Attn: Nelson Payton
Re: Marie Bauer Early Childhood Center
Change Order Request-38; COR-38
CPR-08

Attn: Nelson Payton
Re: Marie Bauer Early Childhood Center
Change Order Request-30; COR-30
CPR-10
Nelson,

Project: Marie Bauer Early Childhood Center
Paso Robles Joint Unified School District

Project: Marie Bauer Early Childhood Center
Paso Robles Joint Unified School District

1 Opening (RHR): 21

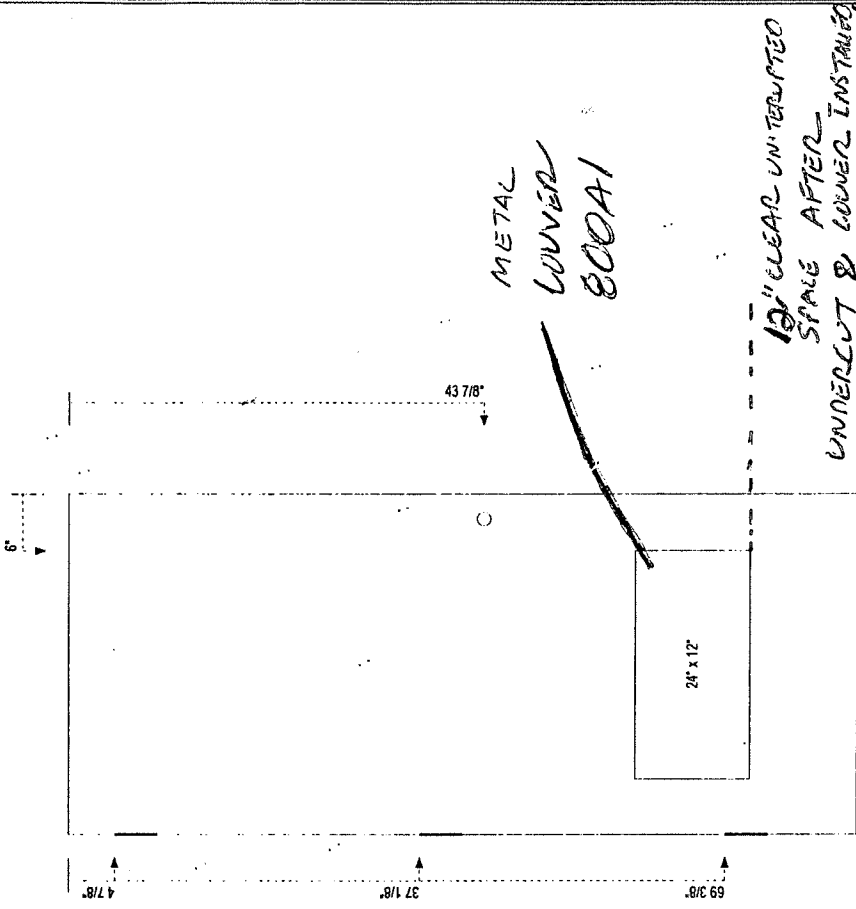
DESCRIPTION	QTY	UNIT	EXTENSION
Request No.: 08			
Swing change at Opening 21. New Hollow Metal Frame. Updated changes made, Louver added to wood door prep. Cut out and Louver supplied by the wood door manufacturer. Changed to hardware set group 04. New lockset to be included.			
Material Add: *Supply Only			
HM Frame 3'0" x 7'0" 16AG Non Rated RHR	1	\$320.00	\$320.00
WD Door VT Industries cut out charge & supply Air Louvers Model 800A1 24" x 12".	1	\$284.27	\$284.27
Cylindrical Office Lockset Schlage ND50TD RHO 626	1	\$283.20	\$283.20
Manufacturer's Freight	1	\$100.00	\$100.00
SDF UPS Out	1	\$25.00	\$25.00
Material Total			\$887.47
Tax		7.75%	\$68.78
Freight (Vendor & Jobsite Delivery)			\$125.00
Labor			\$0.00
Engineering			\$0.00
Sub total			\$1,081.25
15% OH&P			\$162.19
Exclusion:			TOTAL CHANGE AMOUNT
Installation by others.			\$1,243
Sign:			
Print:			
(Mike Matlock, Project Manager)			(AUTHORIZATION TO PROCEED SIGNATURE)

CPR-10
EX1.0
E2.0

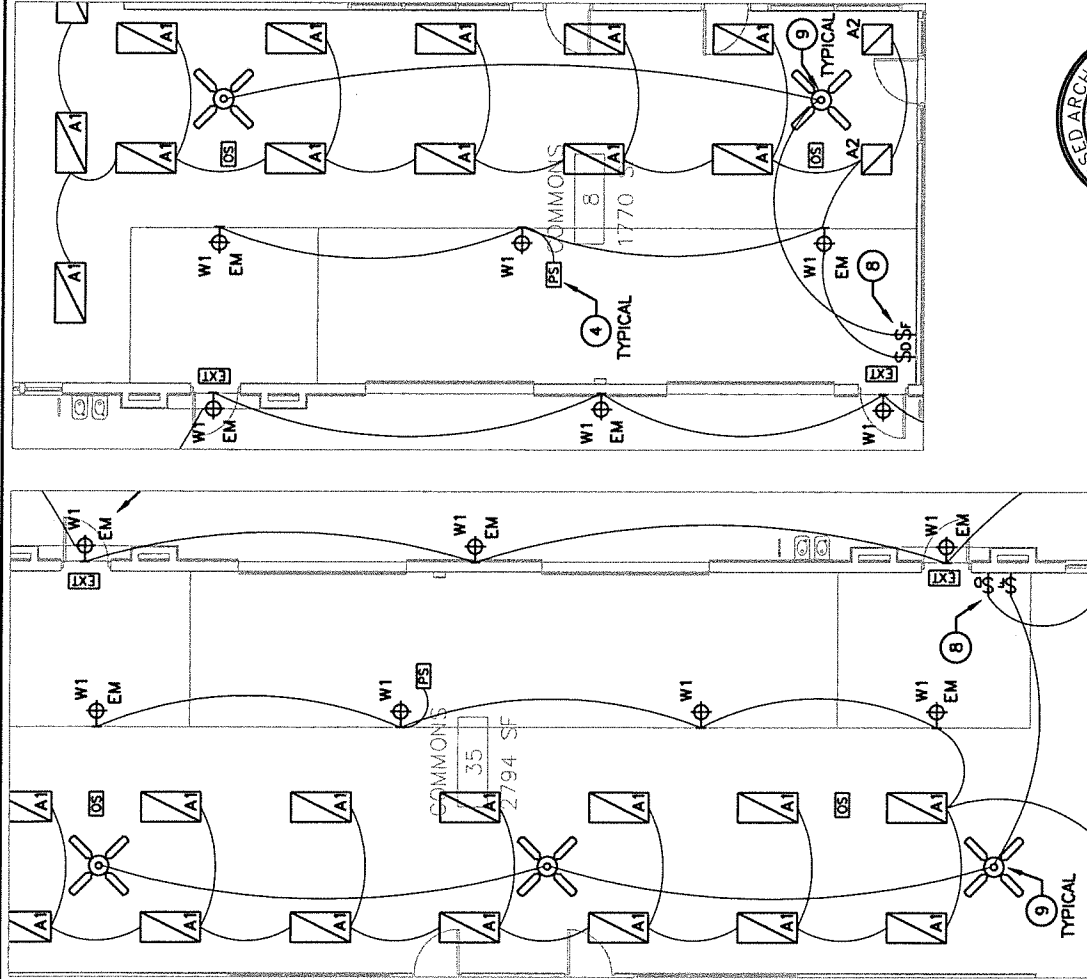
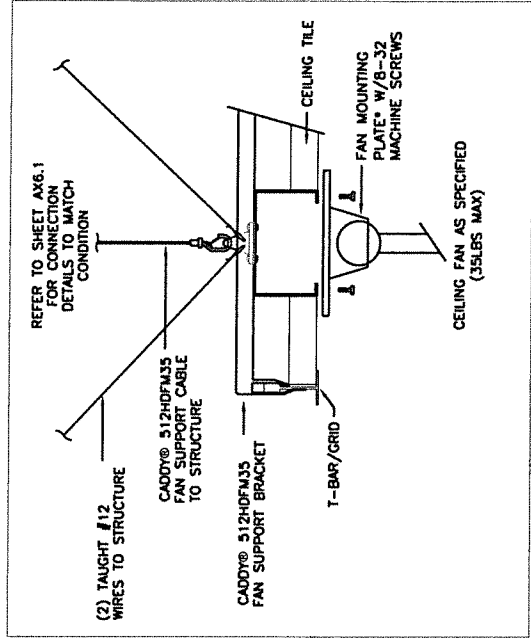
1. Commons 8:
 - 1.1. Provide two (2) new Craftmade Ceiling Fans (Model Inspo – INS54).
 - 1.2. Provide mounting bracket for T-Grid
2. Commons 35:
 - 2.1. Provide three (3) new Craftmade Ceiling Fans (Model Inspo – INS54).
 - 2.2. Provide mounting bracket for T-Grid

- CO-LOCATE FAN AND COMMON AREA LIGHT SWITCH NEXT TO SOUTHERN EXIT DOOR. FAN SWITCH SHALL BE ON/OFF ONLY.
- PROVIDE NEW CEILING FANS. CRAFTMADE INSPPO WITH WHITE FINISH MODEL#: INSS4W3. CONNECT COMMON AREA FANS TO UNSWITCHED LIGHTING CIRCUIT IN AREA SERVED. REFER TO LIGHTING CIRCUIT ASSIGNMENT EXHIBIT. REFER TO MOUNTING DETAIL THIS SHEET.

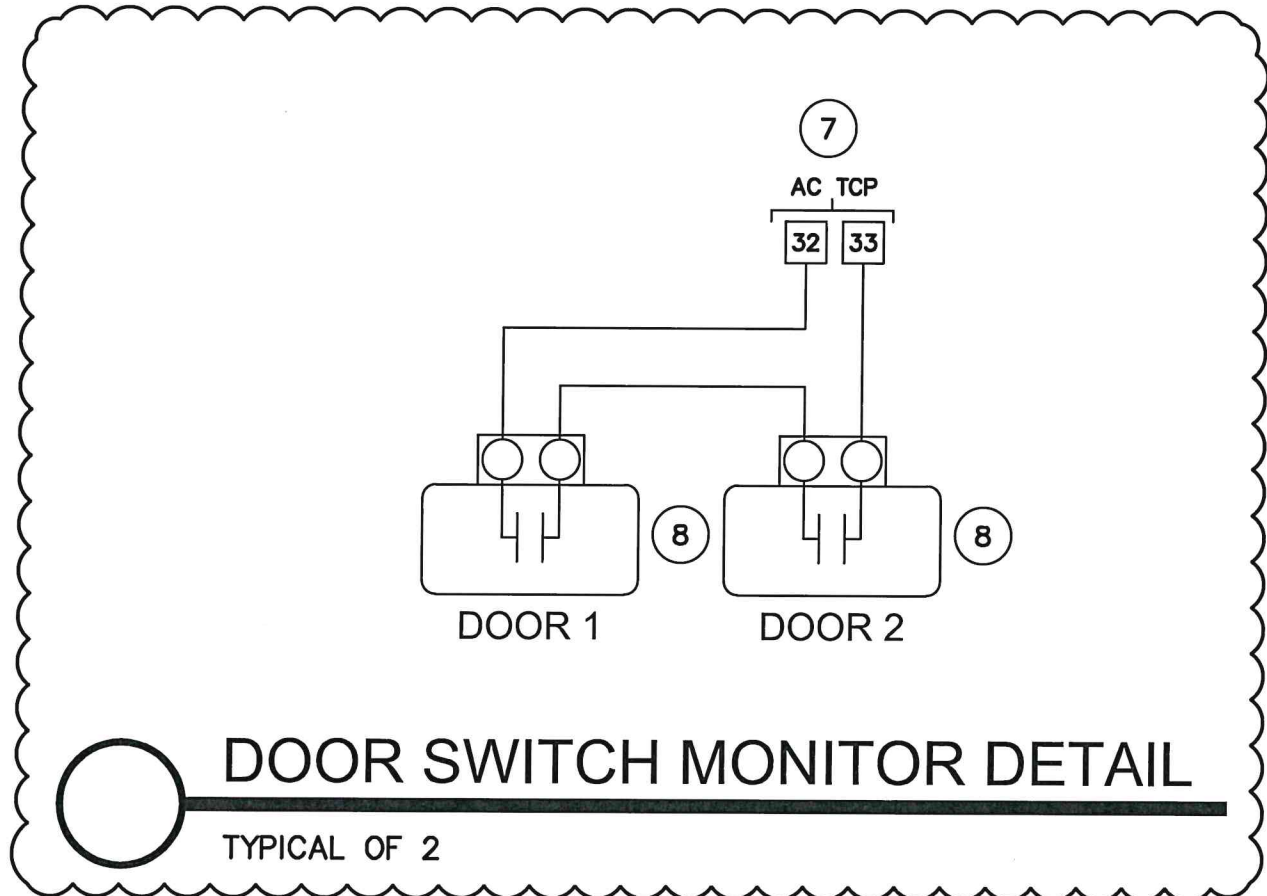
- 1) Add Auxiliary Limit Switches to roll-up doors 8B, 8C, 35B, and 35C
- 2) Provide low voltage connection between roll-up doors 8B, 8C, 35B, and 35C to AC Unit (AC-A6 and AC-B6)
TCP

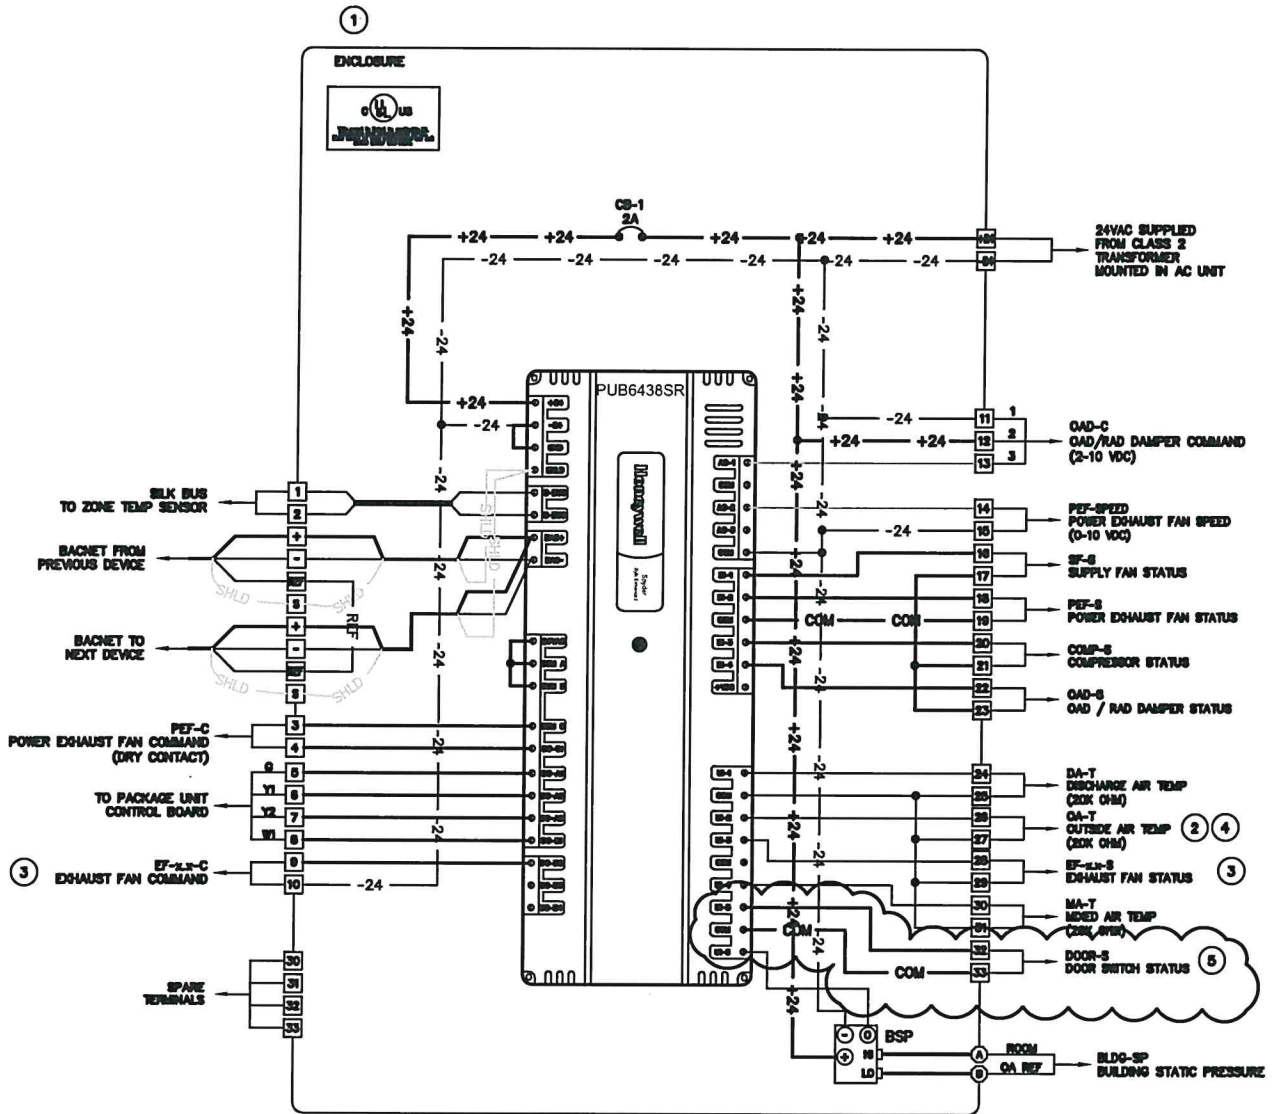
- ① LINE VOLTAGE & CONDUIT BY ELEC CONTRACTOR
- ② OAT INSTALLED ON ONE AC UNIT ONLY AND SHARED GLOBALLY
- ③ VFD IS FACTORY PROVIDED
- ④ ECONOMIZER DAMPER ACTUATORS ARE FACTORY PROVIDED
- ⑤ EF-A5 INPUTS AND OUTPUTS WIRED TO AC-A5 TCP PANEL ONLY
- ⑥ EF-B6 INPUTS AND OUTPUTS WIRED TO AC-B6 TCP PANEL ONLY
- ⑦ FOR AC-A6 AND AC-B6 ZONES ONLY
- ⑧ SWITCH PROVIDED BY DOOR MANUFACTURER TERMINATE AT DOOR TERMINAL STRIP

1 IEP Conference Room [16]

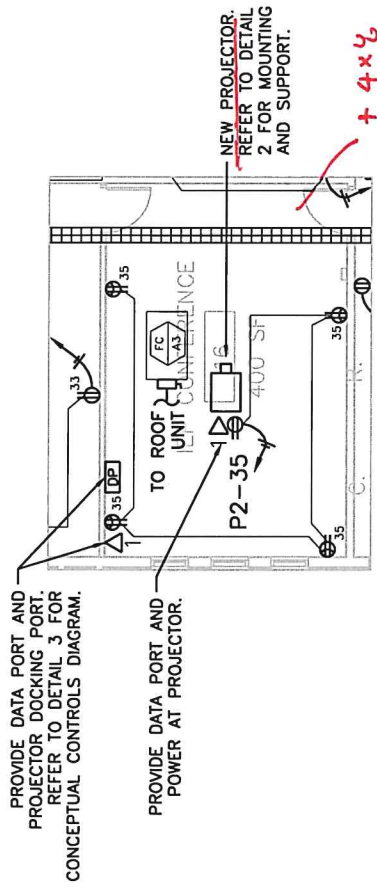
1. IEP Conference Room 16: (OF)
 - 1.1. Provide new projector
 - 1.2. Provide new data and power connections to new projector
 - 1.3. Provide input docking wall plate
 - 1.4. Provide new projector screen to be mounted to the east wall. Reefer to wood stud blocking detail 8/AX5.1. Use #10x3" SMS for attachment.

2 Projector Support in Grid Ceiling

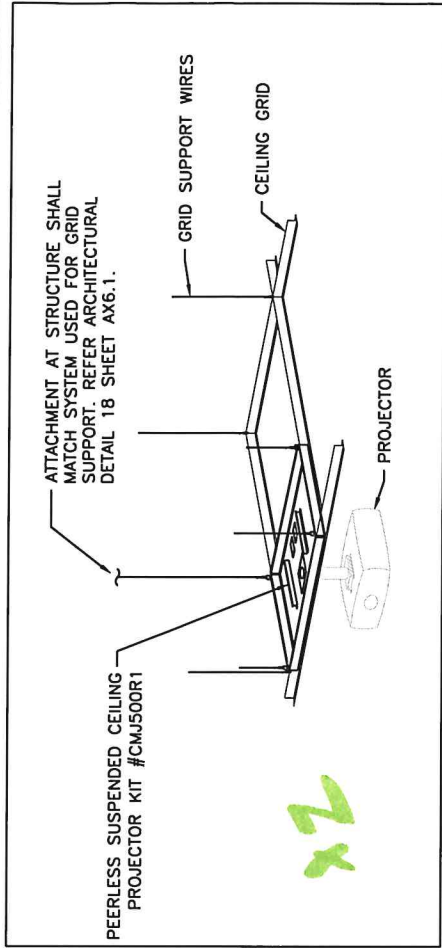
BASIS OF DESIGN PEERLESS MOUNTING KIT #CMJ500R1 - <30LB TOTAL ASSEMBLY CAPACITY
